# SERVICE BULLETIN

Service Bulletin No. 475C  
(Supersedes Service Bulletin No. 475B)  
Engineering Aspects are  
FAA Approved

SUBJECT: Crankshaft Gear Modification and Assembly Procedures

MODELS AFFECTED: All Lycoming direct drive piston aircraft engines (including VO-360 and IVO-360; excepting O-320-H, O-360-E, LO-360-E, TO-360-E, LTO-360-E, and TIO-541 series engines).

Figure 1. Details for Repairing Pilot Diameter of Crankshaft

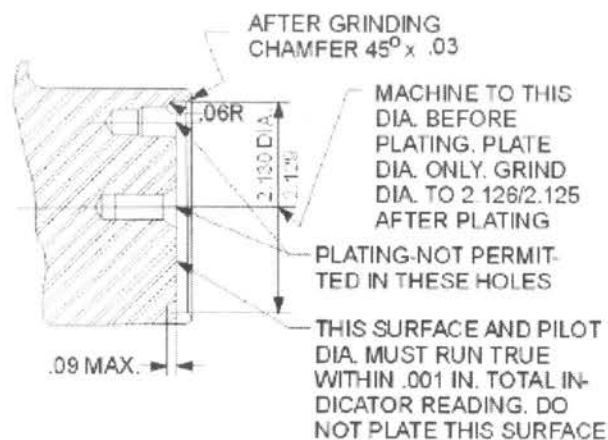
3. Check the pilot diameter of the counterbore on the end of the crankshaft for size and evidence of damage. This diameter should not exceed 2.1262 inches when measured at any location. If found to be oversize, the crankshaft may be repaired as described in the following steps. Do not attempt to reuse a crankshaft with an oversize pilot diameter.

- a. After removing the dowel, machine the pilot diameter in the end of the crankshaft to 2.129/2.130 inch as shown in the illustration. See Figure 1. Also, cut the .09 deep x .06R undercut as shown.

- b. Chrome or nickel plate the surface of the pilot diameter with a firmly bonded deposit that is free of pin holes, blisters and any other imperfections that could impair the function of the parts.

- c. After plating, stress relieve the shaft by baking at 390° to 410°F for 3 to 5 hours.
  - d. Grind the plated pilot diameter surface to 2.125/2.126 inch. Note that the diameter must run true with rear main journal within .001 inch total indicator reading.

- e. Chamfer edge of pilot diameter  $45^\circ \times .03$  as shown in Figure 1.
4. If the dowel has been removed, check the condition of the dowel hole in the crankshaft. If out of round or oversize, ream as required for installation of an oversize dowel. Available oversize dowels and the corresponding size for reamed holes are shown in Table 1.
5. Install a new dowel in the crankshaft as shown in Figures 2 and 3. Insure that the correct dowel is installed.

Figure 2. Section Thru End of Crankshaft Showing Driven Height of STD-1065 Dowel

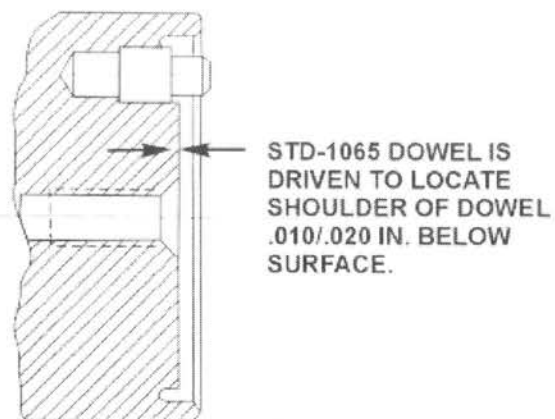
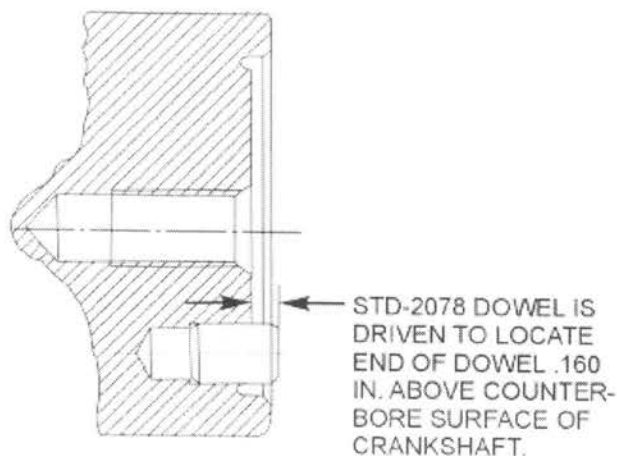
2. Check the condition of the dowel in the end of the crankshaft. It should be perfectly smooth with no indication of nicks or deformation. If it is out of round, it should be removed and replaced with a new one. Replacement instructions are in paragraph 4. If dowel condition is acceptable, insure that it is installed as shown in Figure 2 or 3.

Figure 5. Details for Rework of Crankshaft Gears to Current Configuration

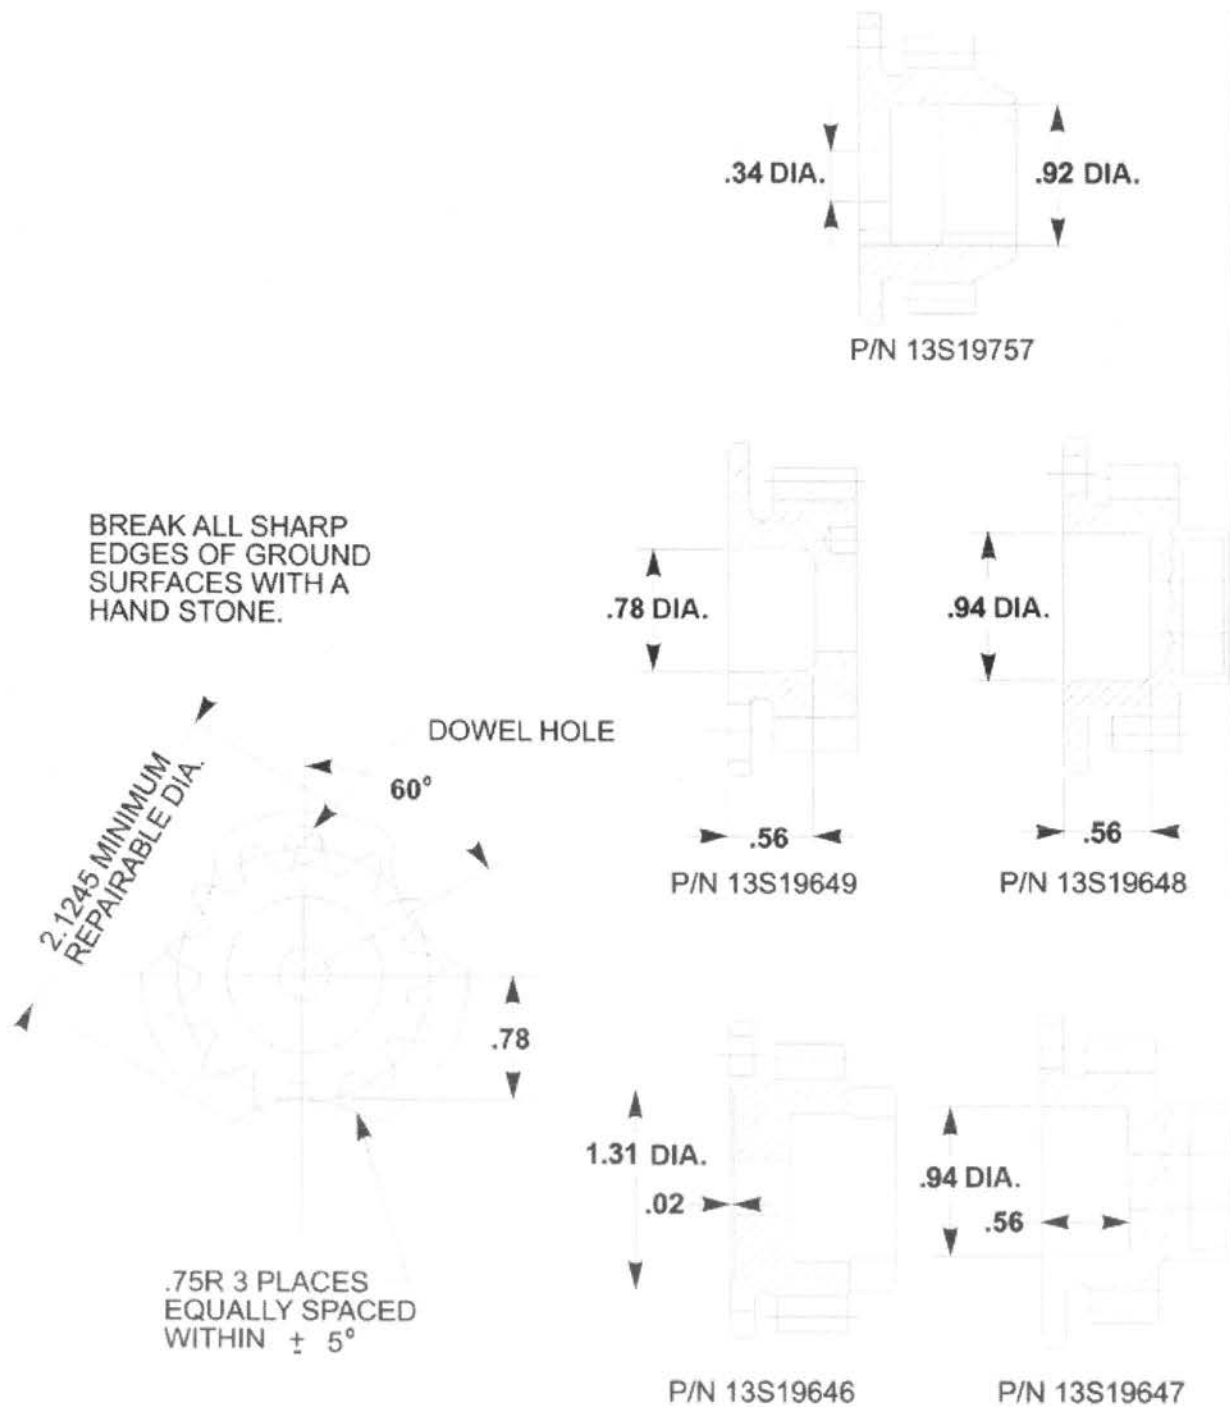
CRANKSHAFT GEARS FOR APPLICABLE ENGINES ARE NOW MANUFACTURED WITH THREE 3/4 INCH RADIUS SCALLOPS CUT INTO THE O.D. OF THE PILOT FLANGE AND A COUNTERBORE ON THE BACK SIDE OF THE GEAR. THESE ENLARGED SCALLOPS HAVE BEEN ADDED TO ALLOW INSPECTION OF THE GEAR AND CRANKSHAFT ASSEMBLY. SERVICEABLE GEARS MUST BE MODIFIED AS SHOWN IN FIGURE 5. PRIOR TO BEING REASSEMBLED ON THE CRANKSHAFT, OR A NEW GEAR THAT HAS BEEN MANUFACTURED TO THIS CONFIGURATION MUST BE INSTALLED. BEFORE MODIFYING THE GEAR, MEASURE THE DIAMETER OF THE PILOT FLANGE. IF IT IS LESS THAN 2.1245 INCH, IT SHOULD NOT BE RESUED. THE ORIGINAL 2.1250/2.1255 DIMENSION OF THE CRANKSHAFT GEAR MUST BE RESTORED WITH A FLASH COPPER PLATE OF UP TO .0005 INCH MAX.

NOTE: Revision "C" revises Table 2 and Figure 5.

Figure 6. Rear End View of Crankshaft Showing Associated Parts

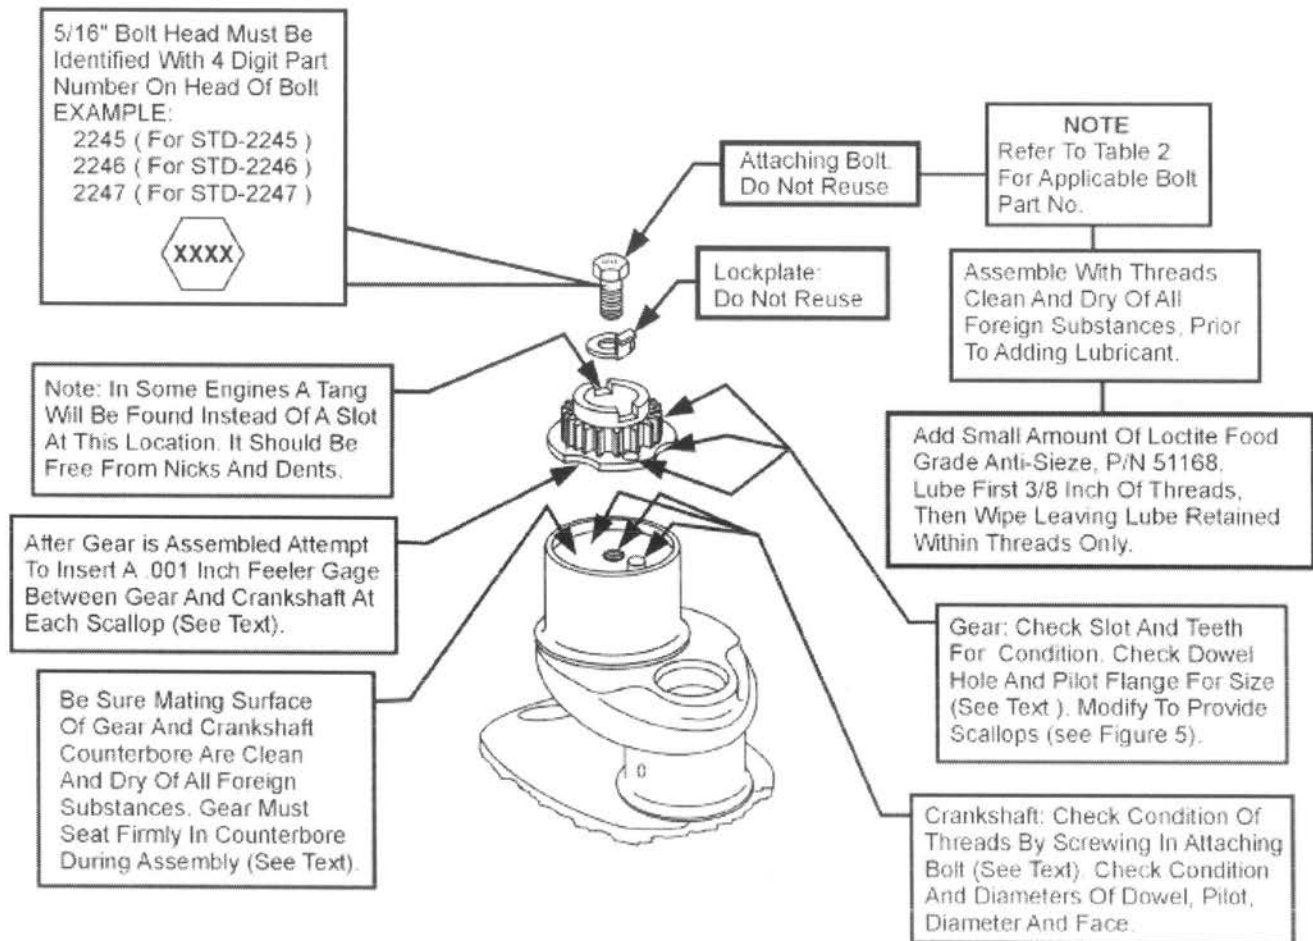
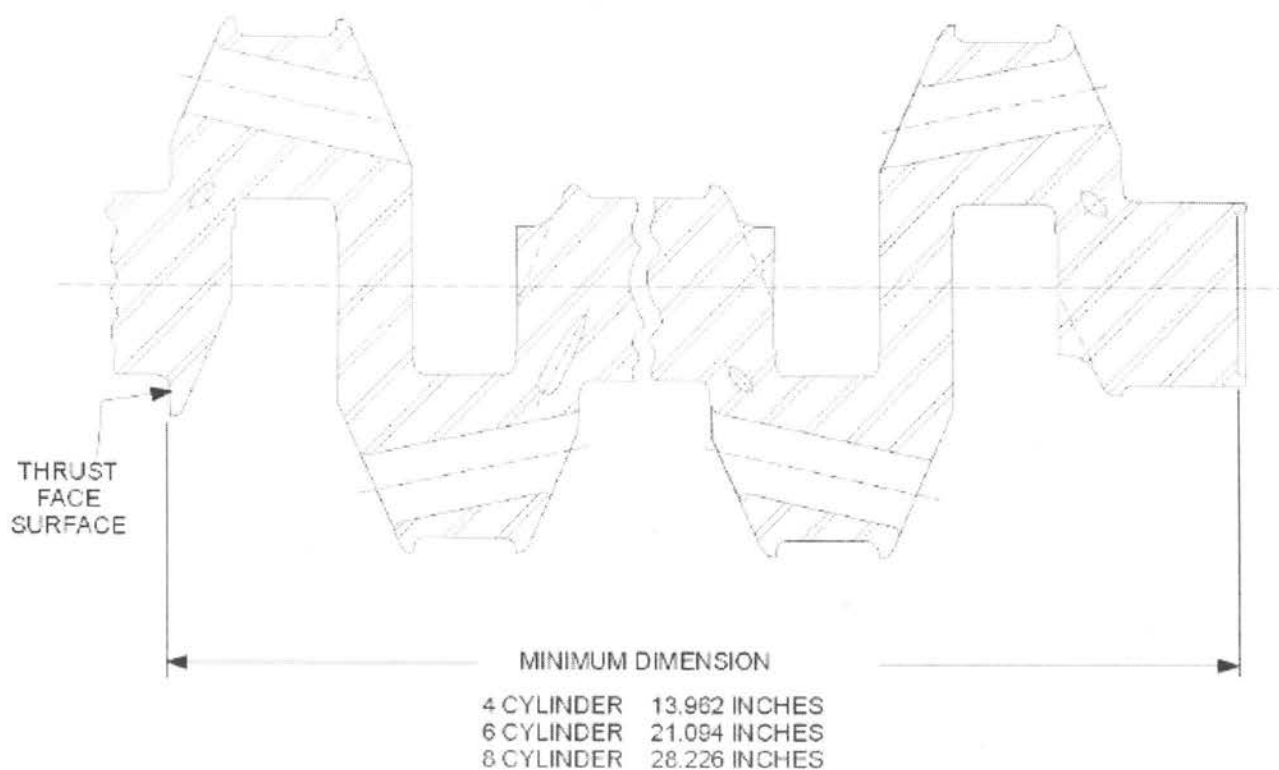
- Assemble the gear to the crankshaft **using both a new lockplate and bolt**. Refer to Figure 6. The correct bolt, lockplate and dowel for each gear are shown in Table 2. Tighten the bolt to 125 in.-lbs. torque, then with a hammer and brass drift, tap lightly around the pilot flange of the gear and listen for sharp solid sounds from the hammer blows that would indicate that the gear is seated against the crankshaft. As a check on the seating against the crankshaft, attempt to insert a pointed .001 inch thick feeler gage or shim stock between the gear and crankshaft at each of the three scallops. The .001 feeler gage, or any smaller feeler gage, must **NOT** fit between the two surfaces at any location. (.001 feeler gage is used as an indicator, however, there must be no clearance between crankshaft and gear.) Retighten the gear attaching bolt to the proper torque. Tighten the 5/16 inch bolt to 204 in.-lbs. torque or the 1/2 inch bolt to 660 in.-lbs. torque. Measure the clearance between the O.D. of the gear flange and the pilot I.D. of the crankshaft. There should not be more than .0005 inch clearance at any point.
